Dissatisfaction with ABT Opti-Flow Burners in IGS Unit 2

This letter is to express the dissatisfaction of Intermountain Power Service Corporation with the performance of ABT's Opti-flow burners that were installed on Intermountain's Unit 2 in the spring of 2004. We are holding ABT at least partially culpable in the recent failure of the Unit 2 F3 burner module and request ABT's assistance in resolving our concerns.

>>> Aaron Nissen 10/15 8:45 PM >>> U2 Outage F Burner Inspection Summary

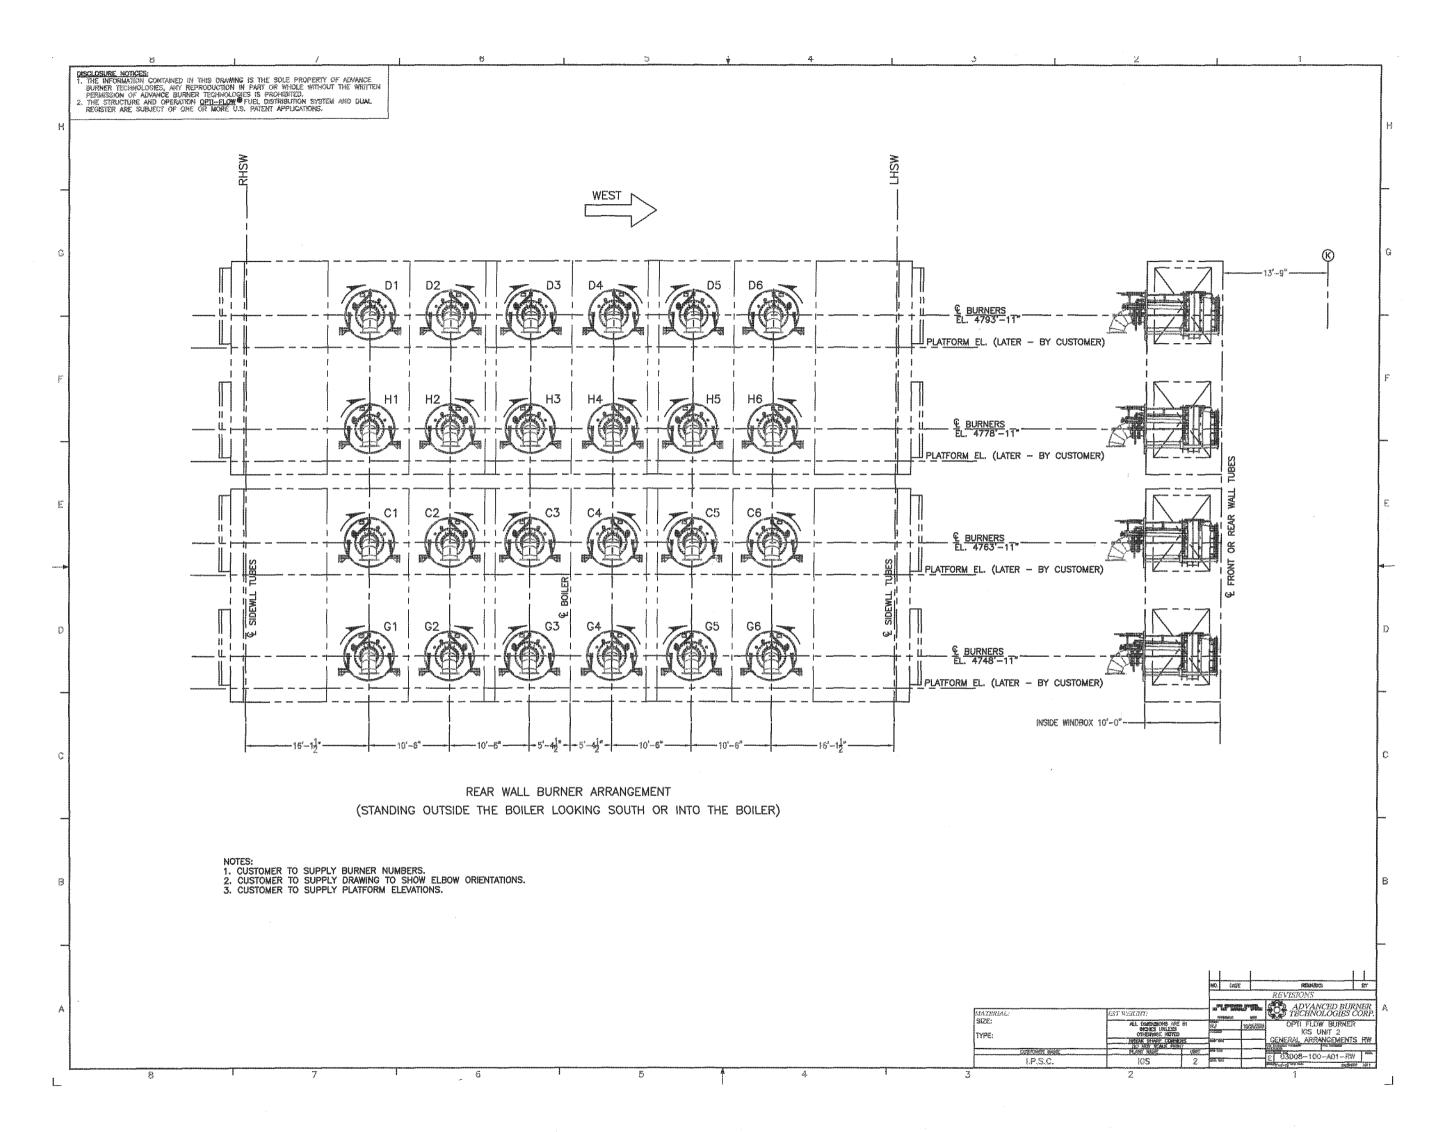
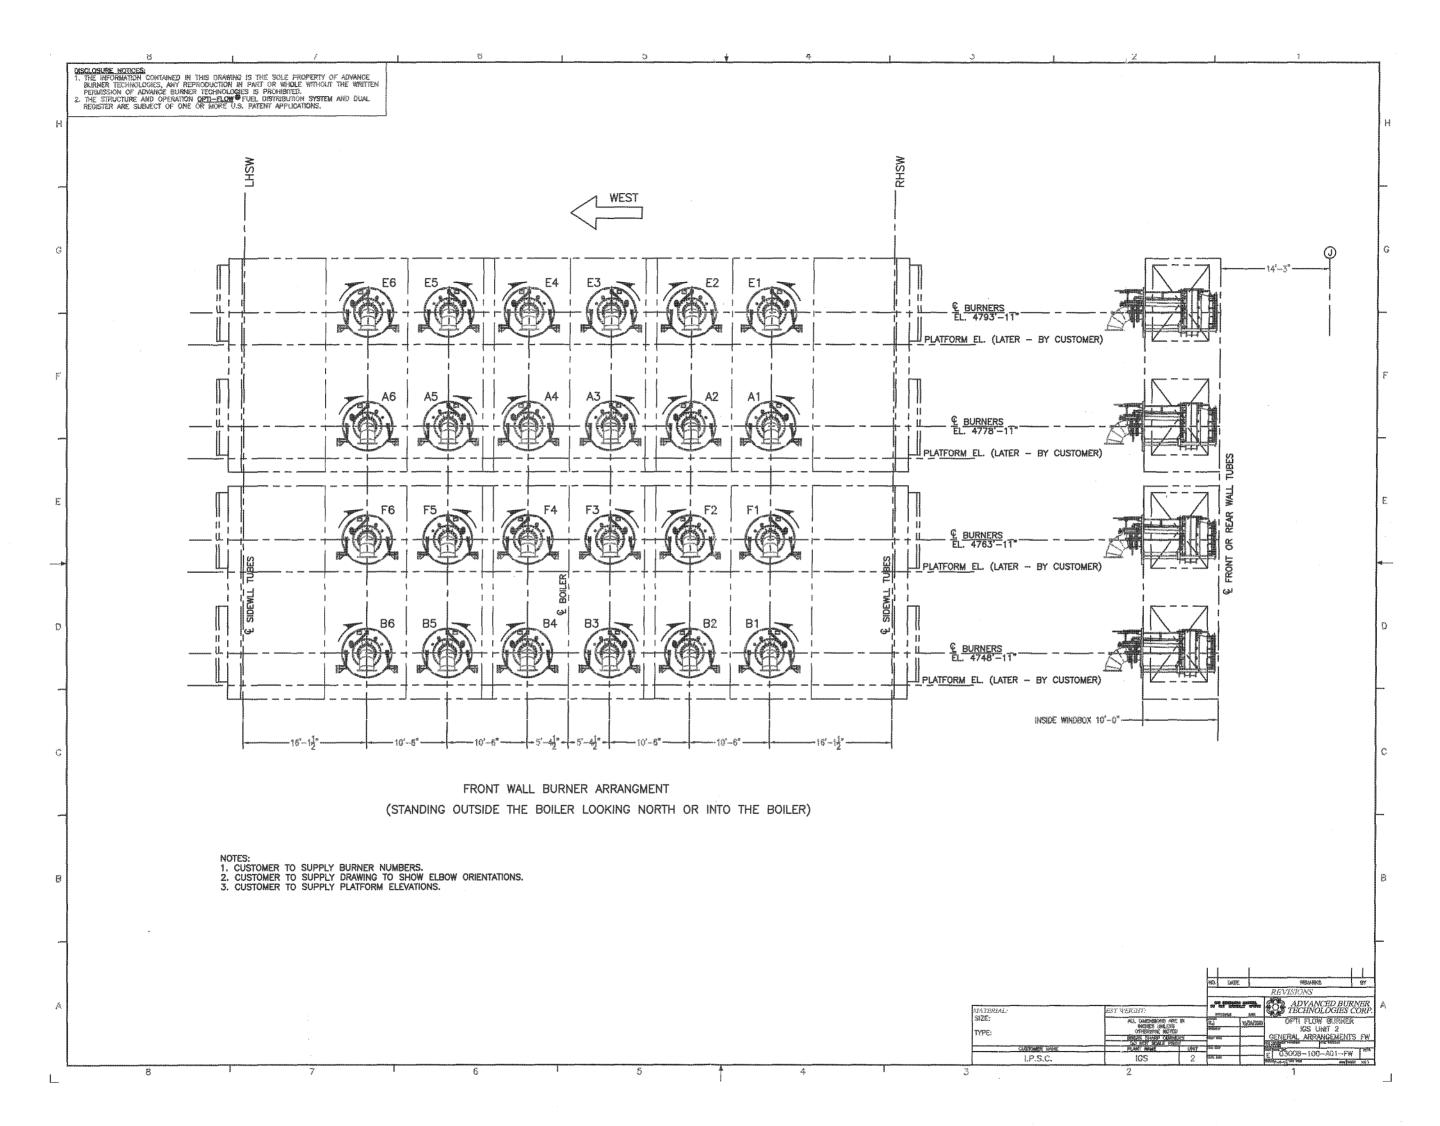
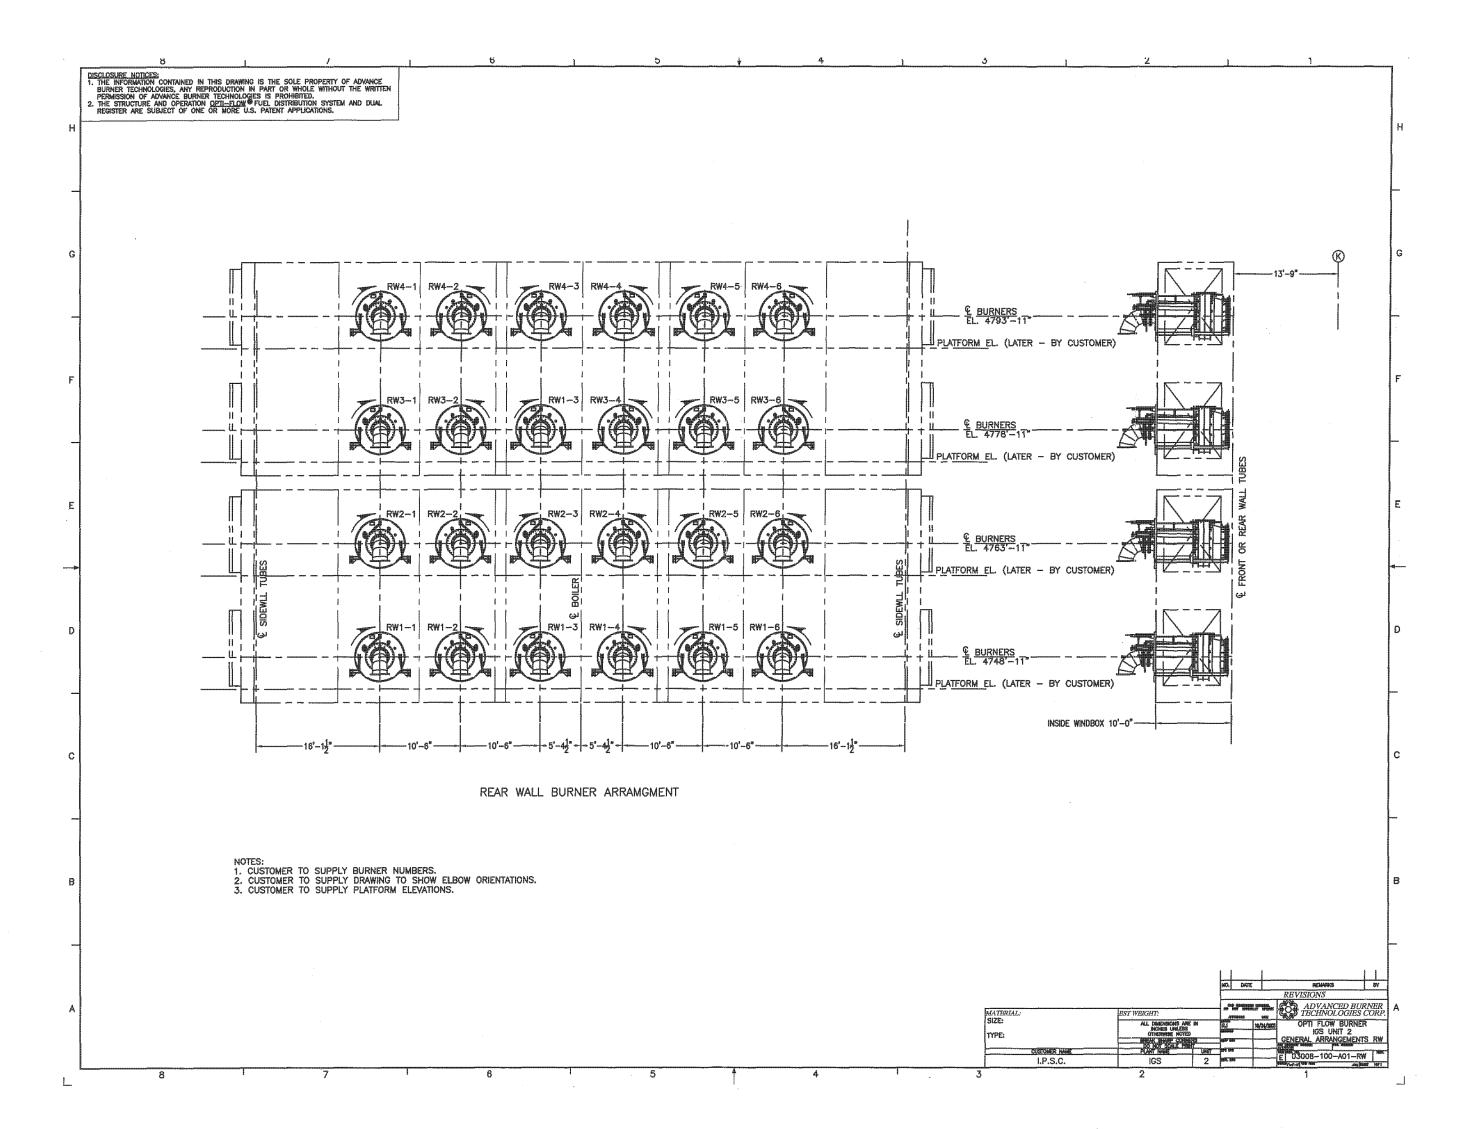
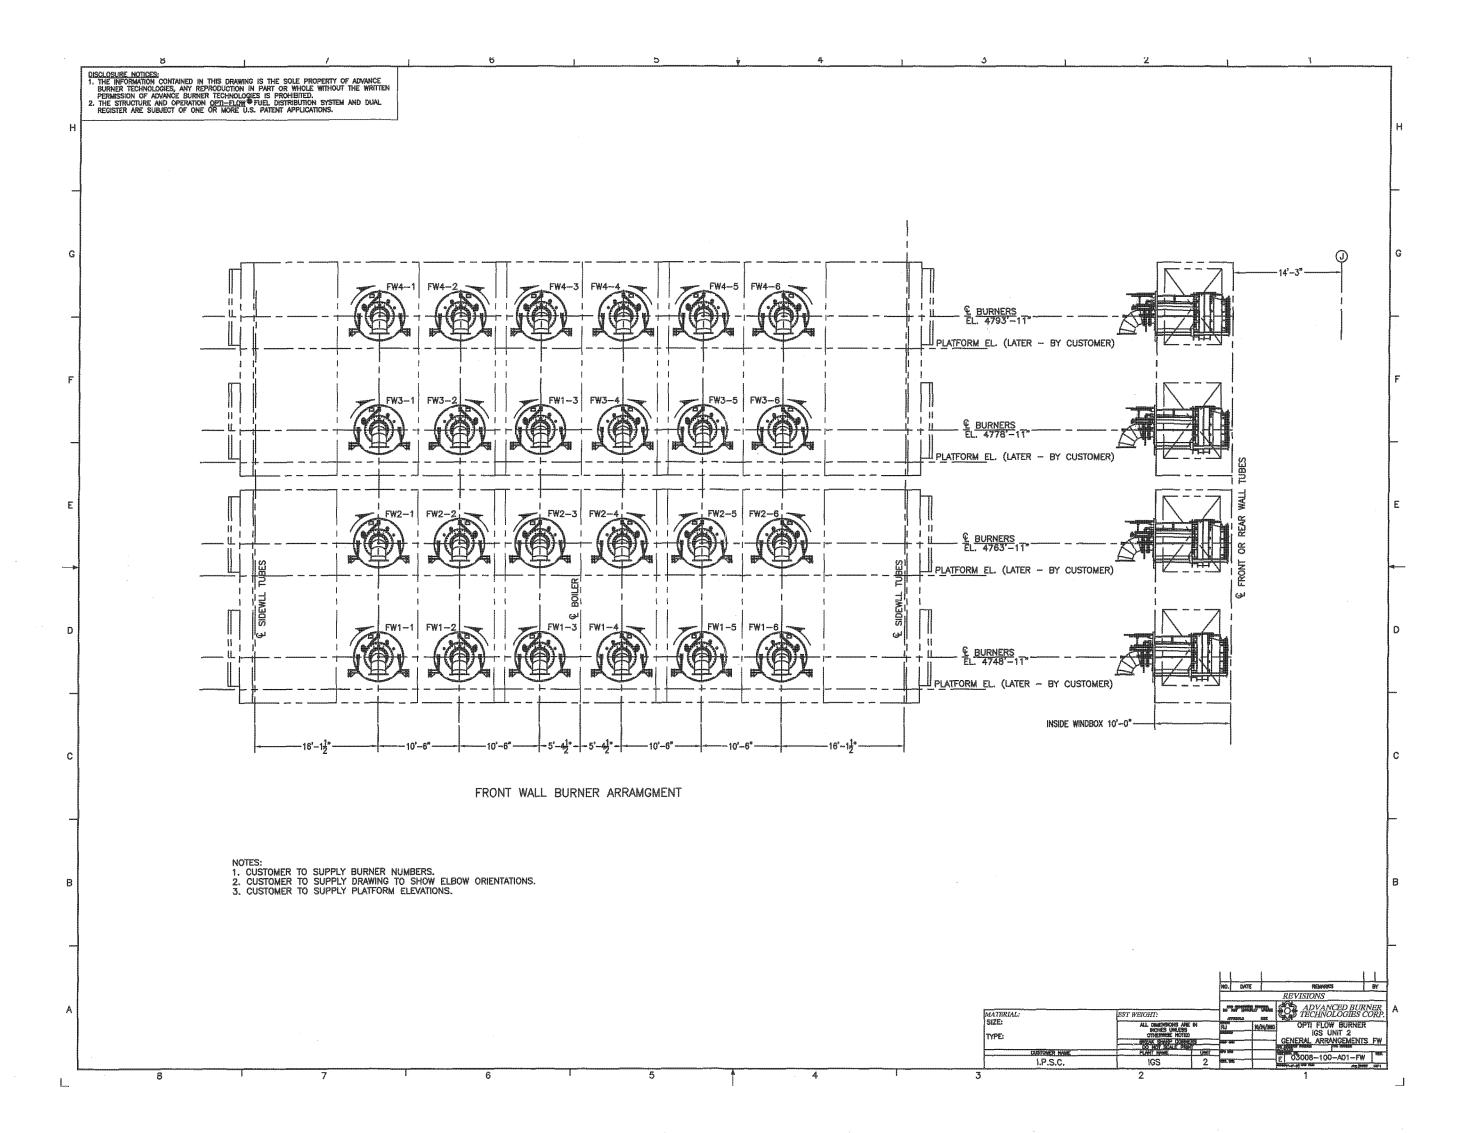
F3 Burner- major meltdown of the coal nozzle into the outer sleeve. 40% of the entire length of the nozzle has melted (bottom right). Due to the damage on the outer sleeve, the burner assembly needs to be replaced (during next Spring U2 Outage), although the air register assemblies look intact. Coal Nozzles- coal erosion found in the 3:00 & 9:00 clock positions on all nozzles (below where the X-vane cross piece rides)

This erosion is within the first 18" of the nozzle. F6 nozzle, left side, had a hole eroded completely through.

Nozzle tips- major erosion and holes in the flowered tip (designed for coal staging), plus cracks in the "high tech alloy". Near impossible to weld up and due to high temps from furnace flame, impractical to RTV or nordbak/ceramic patch. Also the weld interface from the nozzle to the tip has creep damage (warped)

Coal Elbows- major erosion at the top of the nozzle. F1 & F2 already had eroded thru the original ceramic lining and thru the elbow material requiring external patches. F2 had a hole already in the external patch. F4 & F5 had holes eroded in the ceramic, but not yet thru the elbow metal. F6 has not yet eroded through the ceramic.

Coal Nozzles- ALL (except F3) coal nozzle sidewalls weld repaired at (3:00 & 9:00 clock position)
Coal Elbows- ALL (except F3) elbows were ceramic (nordbak) repaired at the very top (holes in ceramic)
F2 also had an external patch installed due to a hole in the 1st external patch

FUTURE: U2 Spring Outage- F3 burner will need to be replaced, as well as all other coal nozzles, preferably

ceramic lined and new designed nozzle tips. Elbows also needed revamped or better yet replaced (so have

one spare set to modify and rotate), also X-vanes needed replaced or modified (they aren't doing their job).
